Reference: Beaver Valley Power Station, Unit No. 1
Docket No. 50-334, License No. DPR-66
Generic Letter 83-28, Items 4.2.1 and 4.2.2

Attached is the Beaver Valley Unit 1 response to your letter of September 13, 1984 requesting additional information on Generic Letter 83-28 Items 4.2.1 and 4.2.2

Response to Request for Additional
Information Regarding Salem ATWS Event
Items 4.2.1 and 4.2.2

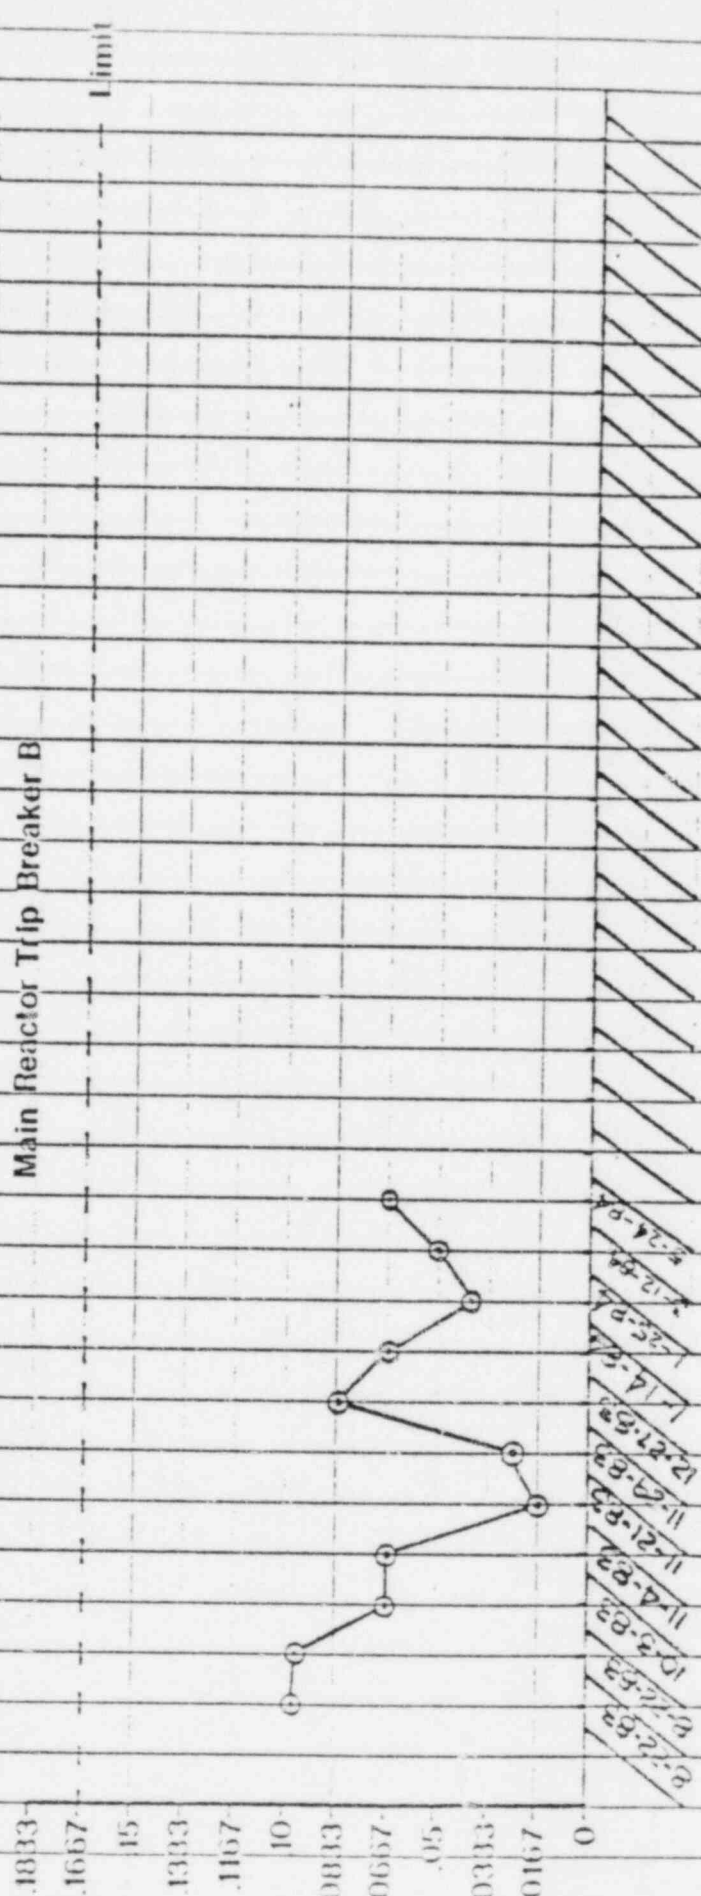
- b. The submittal states that trend report results of the reactor trip breakers will be issued periodically to the plant's upper management staff and significant degradation found during breaker trending will be immediately identified for corrective action. Please provide a discussion of the technical criteria to be used for evaluating trend data. It should include a description of the use of acceptance limits, establishment of baseline values or other basis for identifying significant degradation of the breaker. It should also indicate the schedule or guideline for scheduling evaluation of the trend data.

The data obtained from the various sources is compared to the acceptance criteria and plotted. If an unacceptable or questionable condition is identified, supervision is notified for a determination of appropriate corrective action. The parameters, except reactor trip times, have a tentative review schedule of 18 months, which is consistent with the frequency of the procedures which obtain the data. In addition to the trending review, all the procedure results are reviewed by a maintenance engineer upon completion.

The response time for reactor trips is reviewed on a monthly basis and reported to supervision in a monthly trend report. Attached is an example plot of trip breaker response time.
